Re: 0 Pinecrest Parkway

This letter is to itemize the changes that we have made to the design of the house proposed to be built at 0 Pinecrest Parkway since the February 20 Planning Board meeting.

LIST OF DRAWINGS		SUBMITTED TO PLANNING BOARD AND ZONING BOARD 03-05-2020	SUBMITTED TO ZONING BOARD 04-16-2020
No	SHEET TITLE	ISSUE DATE OR LAST REVISED	ISSUE DATE OR LAST REVISED
CS	COVER SHEET ,LOCATION MAPS, DESIGN CRITERIA TABLE	03-05-2020	04-16-2020
SP-1.1	SITE PLAN	03-05-2020	04-14-2020
SP-1.2	FLOOR PLANS 1/8" = 1'-0" SCALE	03-05-2020	03-19-2020
SP-1.3	ELEVATIONS 1/8" = 1'-0" SCALE	03-05-2020	03-19-2020
SP-1.4	BUILDING SECTIONS, SITE SECTION 1/8" = 1'-0" SCALE	03-05-2020	03-19-2020

SITE PLAN

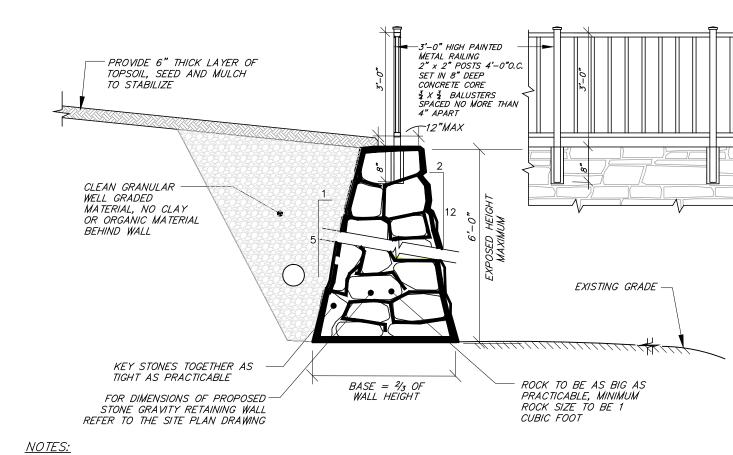
REVISED ADDED RETAINING WALL AT CORNER OF GARAGE RELOCATED HVAC EQUIPT RELOCATED EXTERIOR LIGHTS

REVISED LOCATION OF CONTOURS 184 AND 186 IN EASEMENT
